COPPER CHASE AT STERLING RANCH

CONSTRUCTION PLANS

V2_CDs.pdf Markup Summary

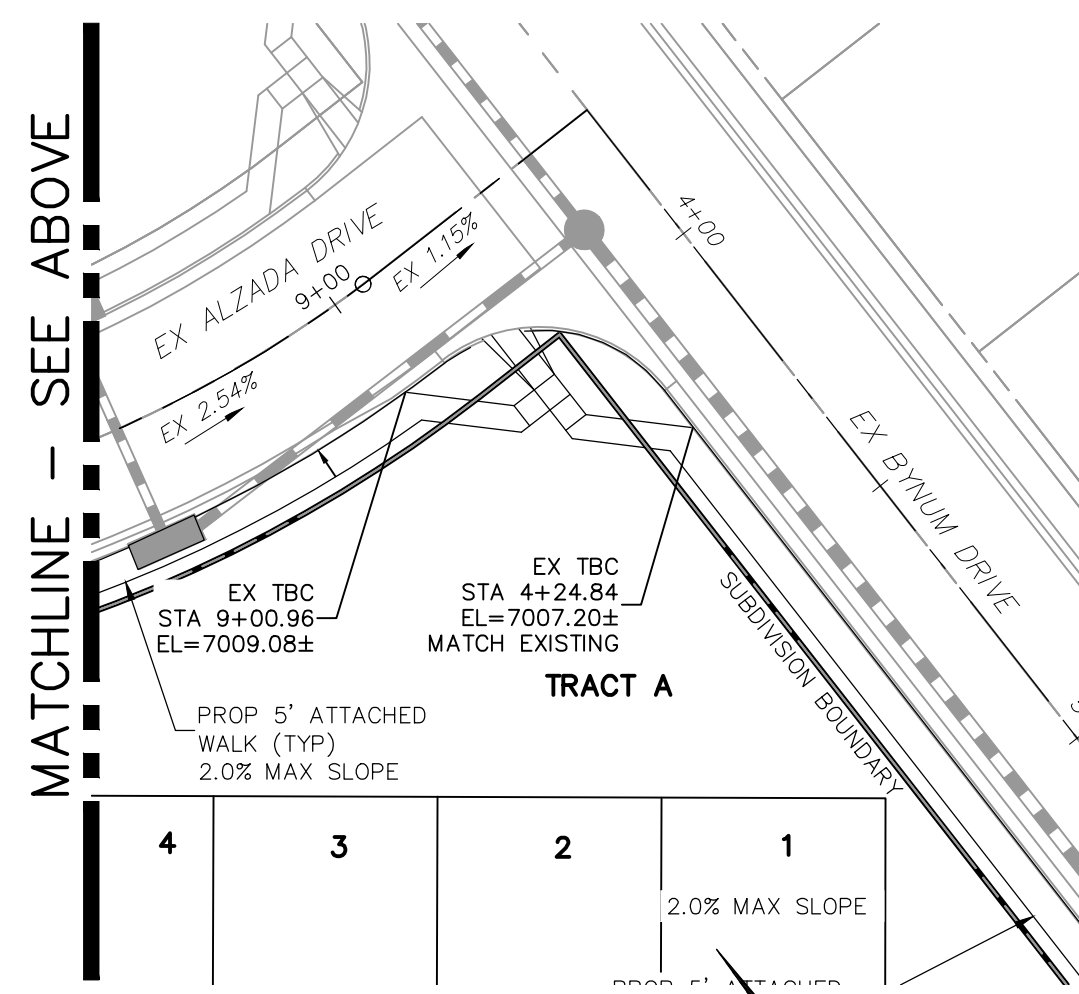
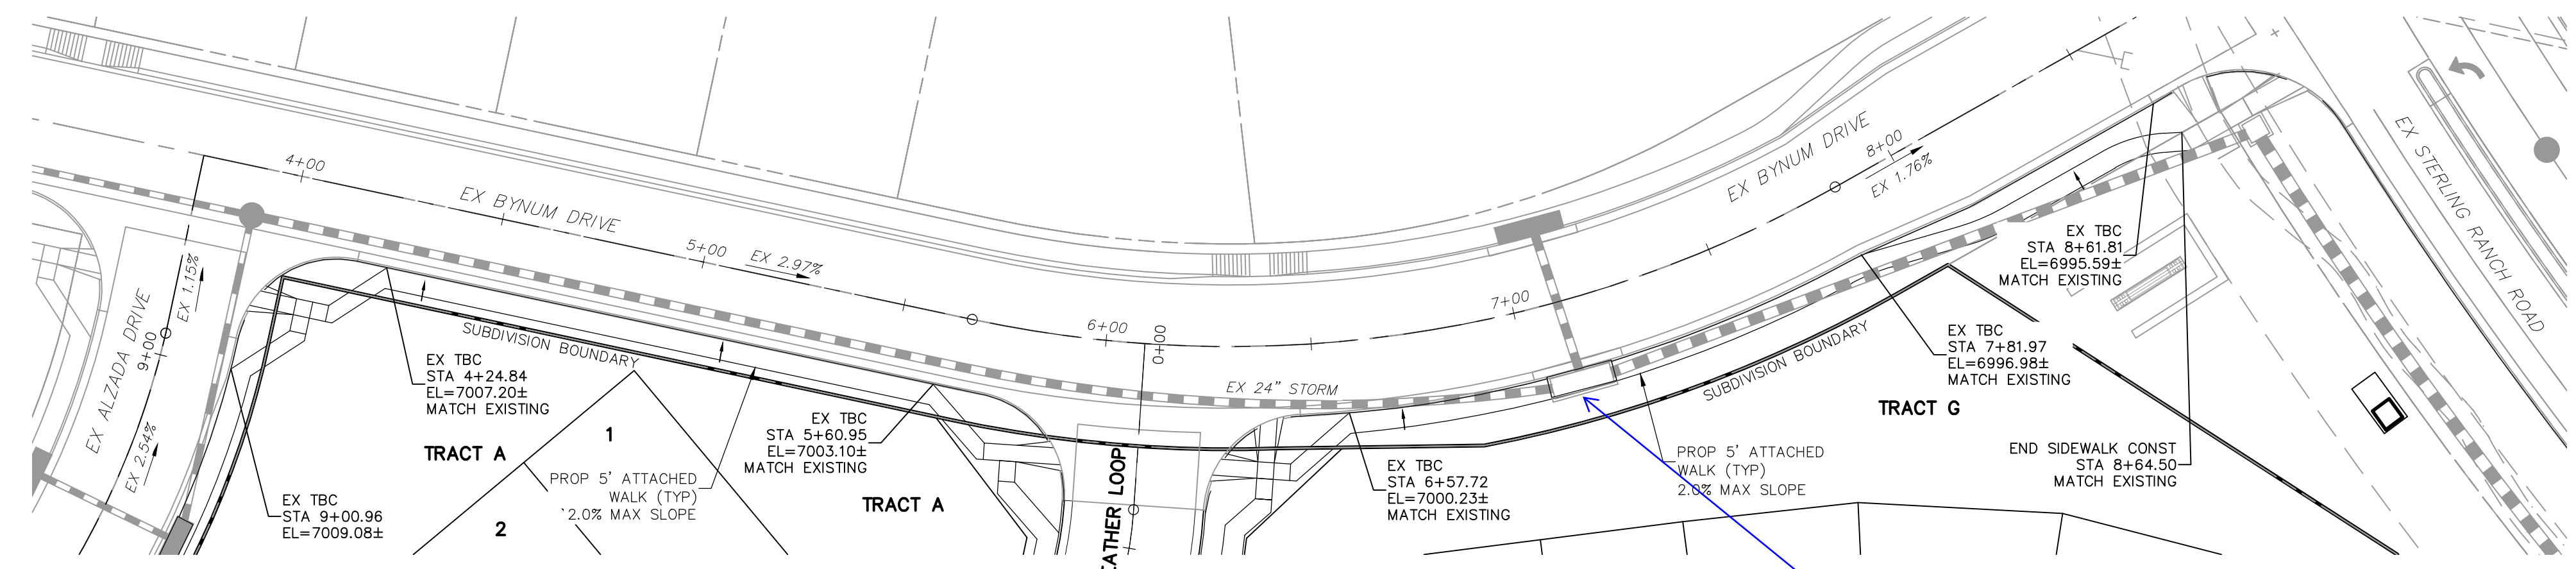
Sidewalk should run behind inlet unless an integrated design is provided. ADA requirements apply. Staff strongly suggests sidewalk behind inlet to avoid settlement issues between sidewalk & inlet.

Sidewalk should run behind inlet unless an integrated design is provided. ADA requirements apply. Staff strongly suggests sidewalk behind inlet to avoid settlement issues between sidewalk & inlet.

Provide elevation of LP

Provide elevation of HP

Provide elevation of HP

Sidewalk adjusted

SI11

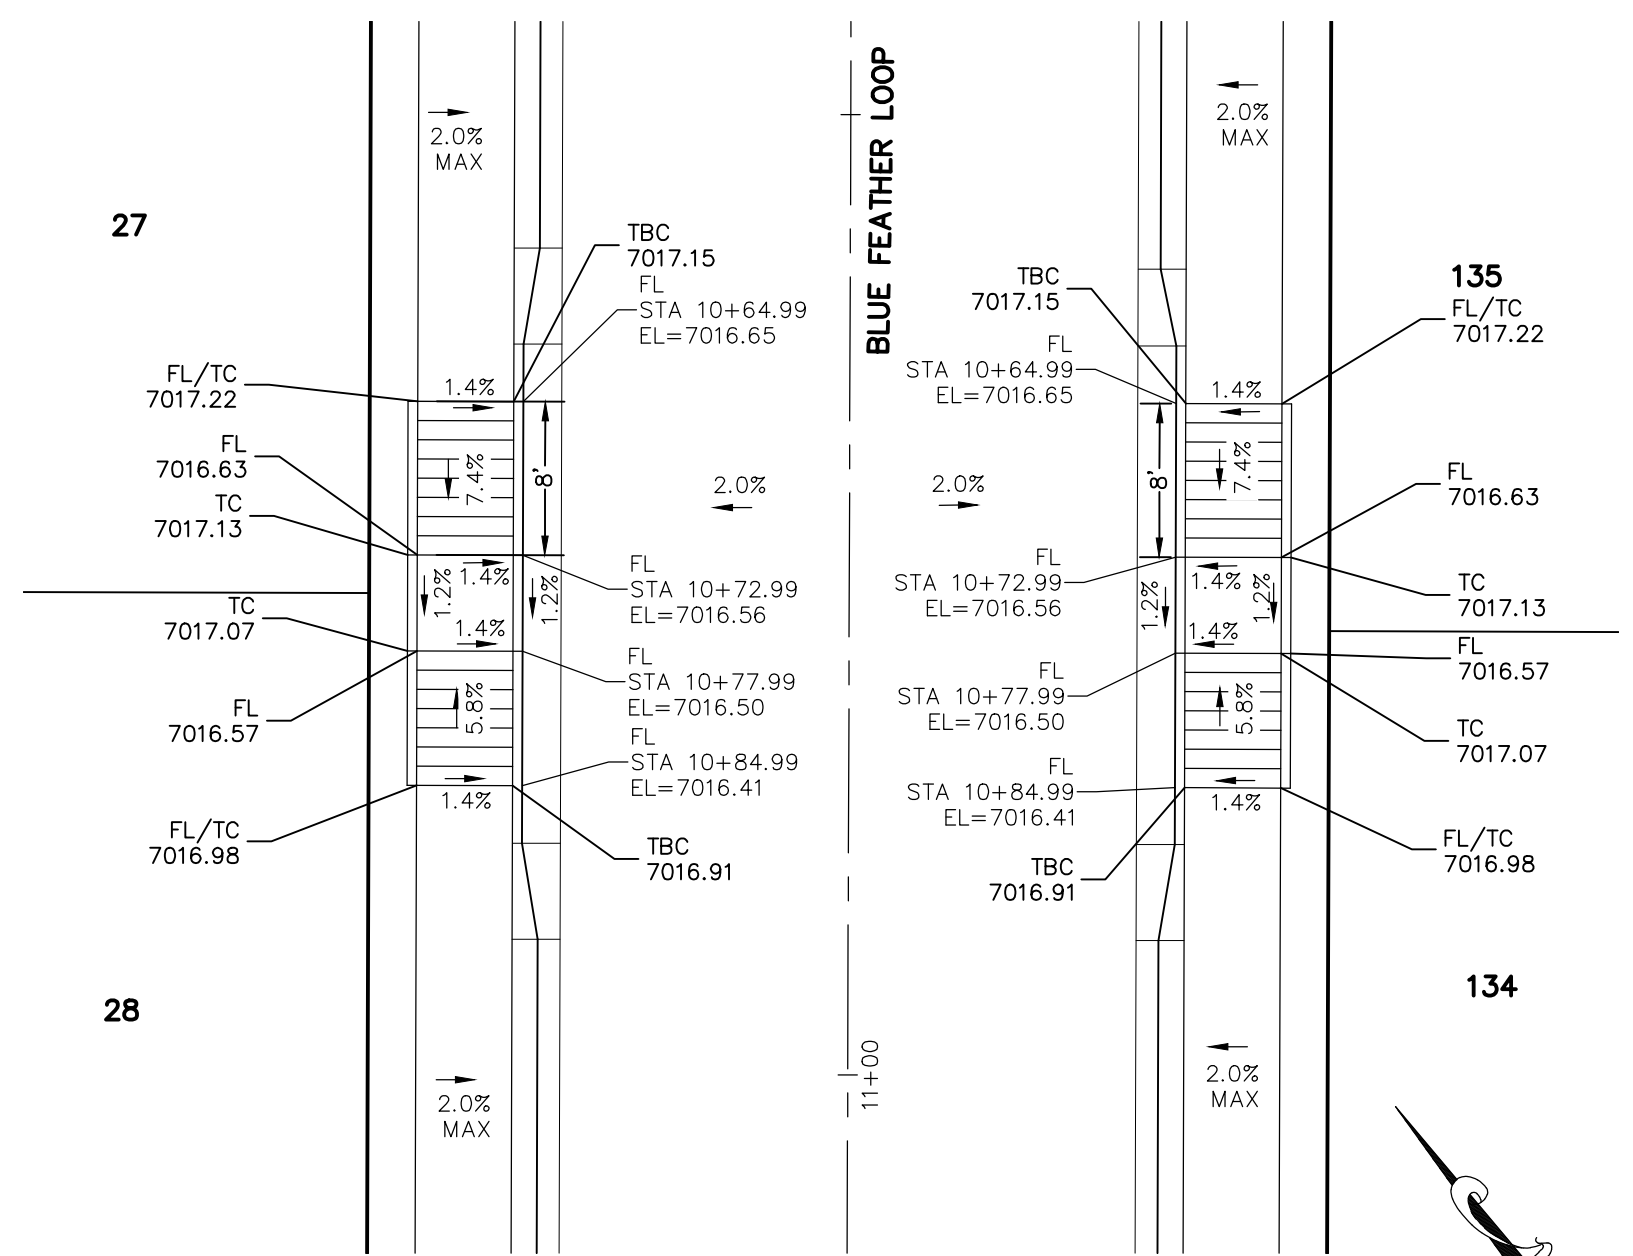
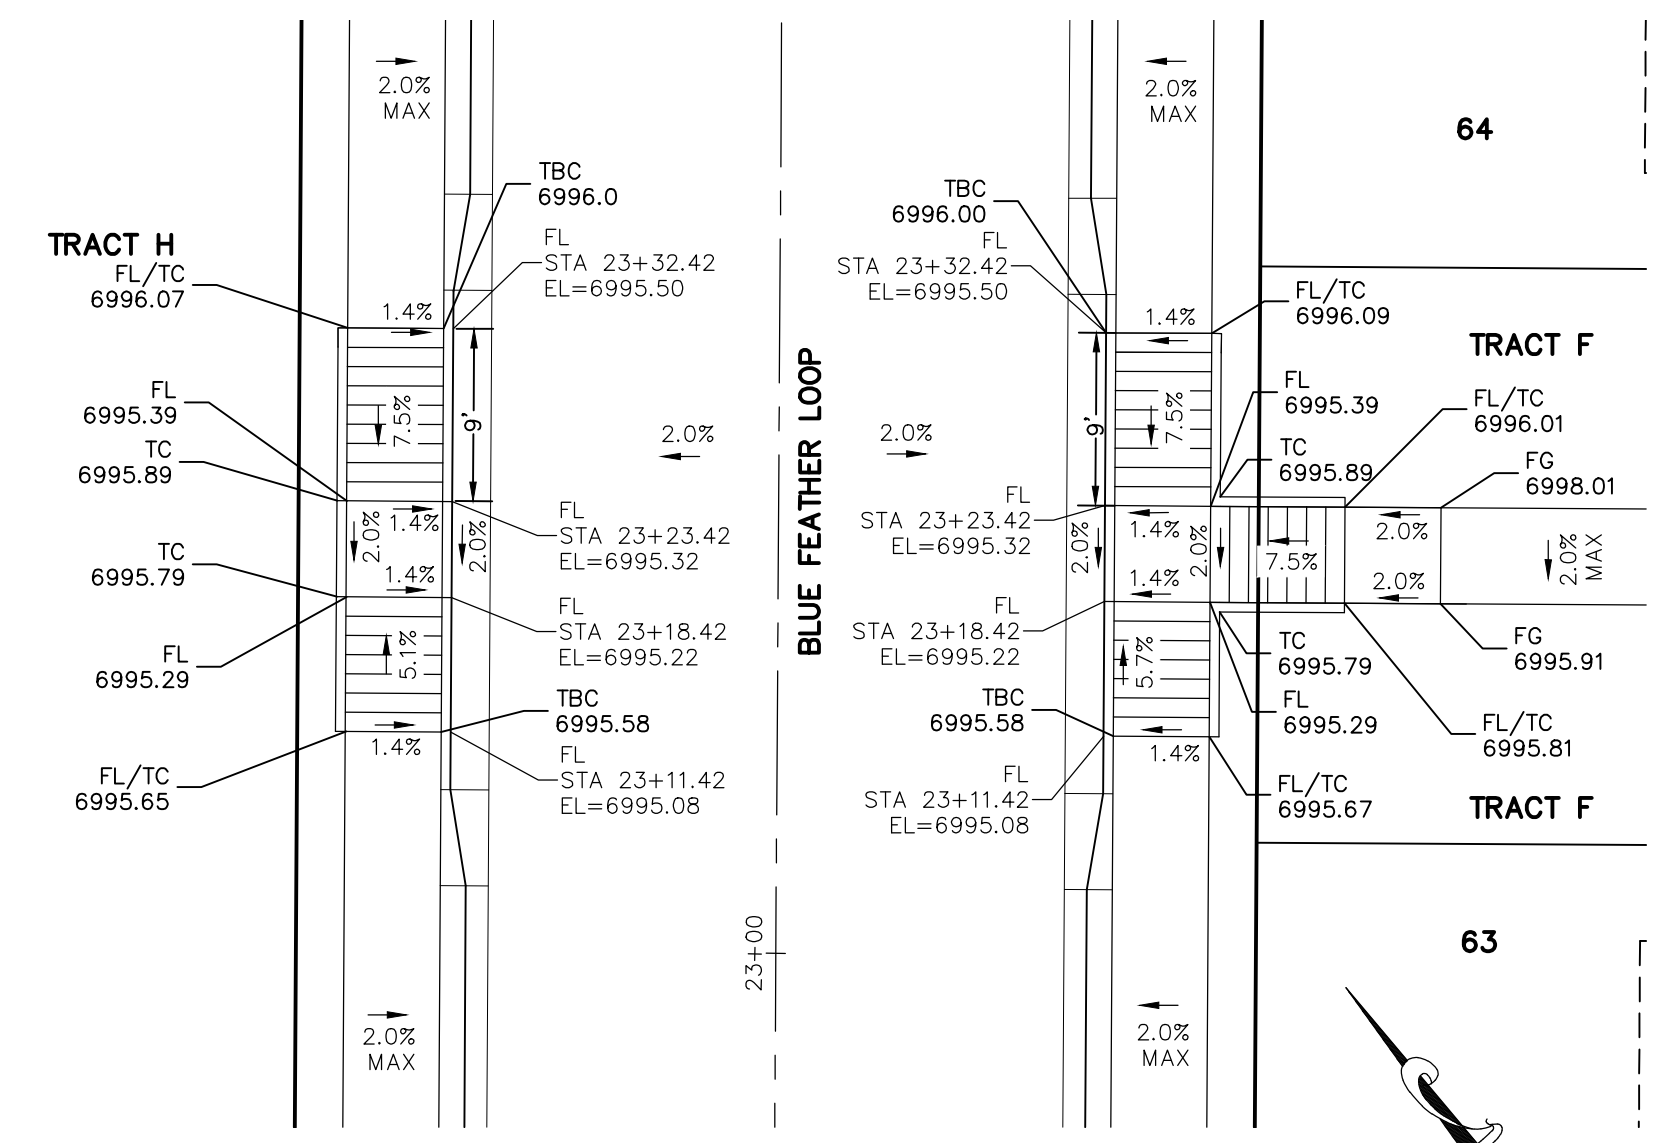
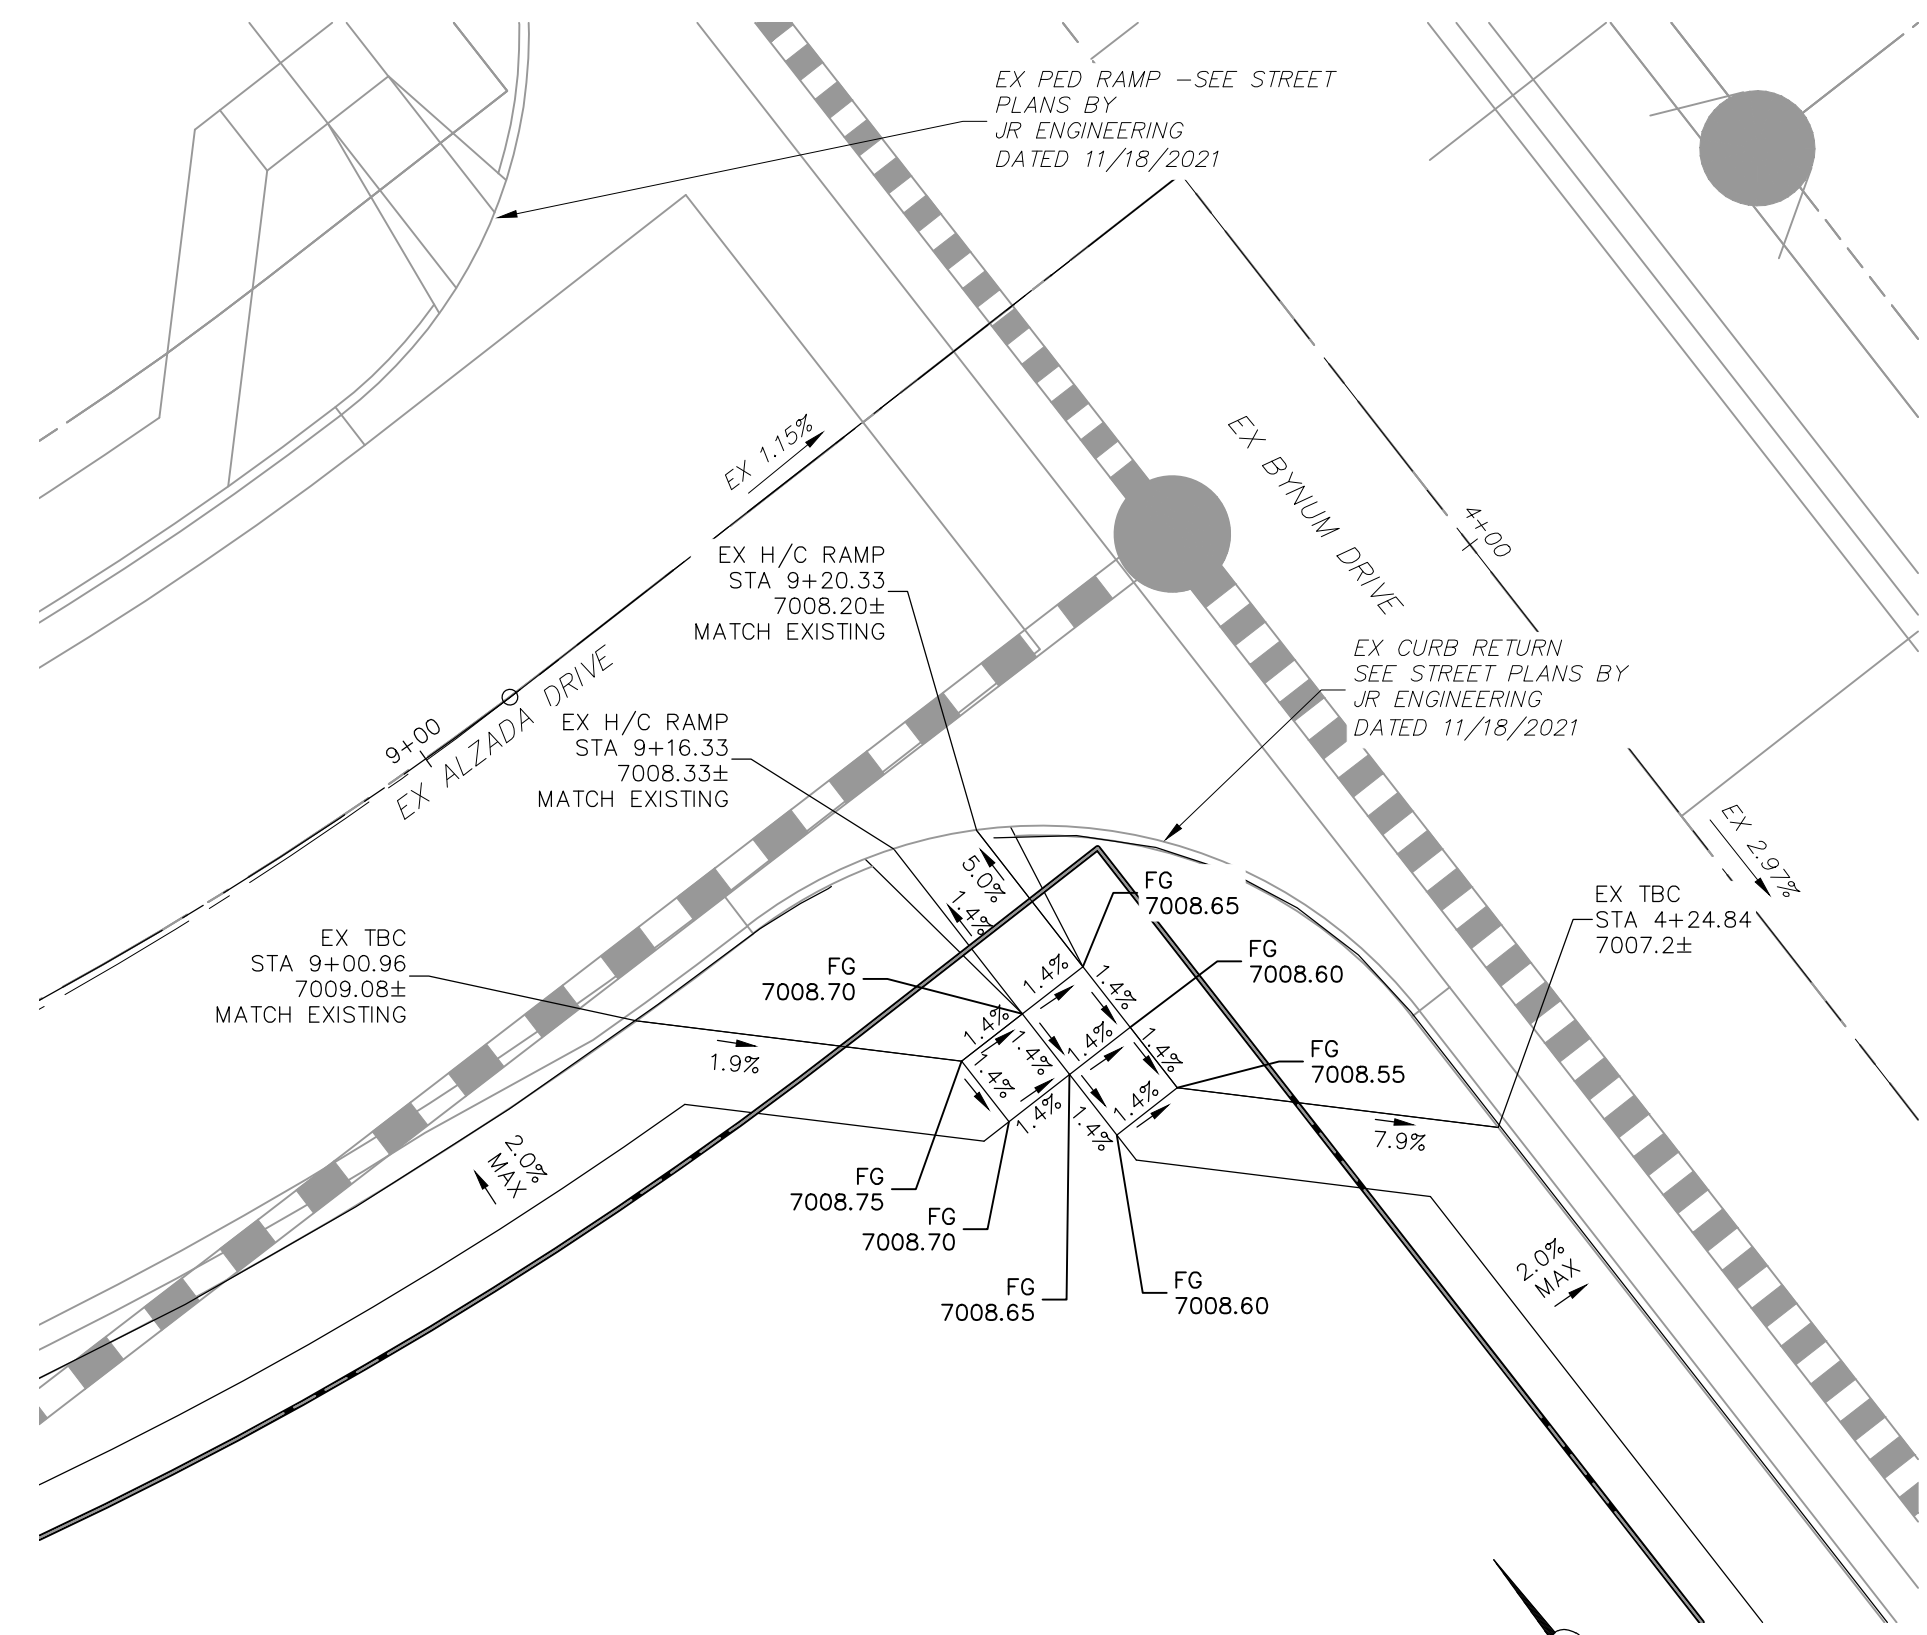
Provide elevation of HP

Provide elevation of LP

Provide elevation of LP
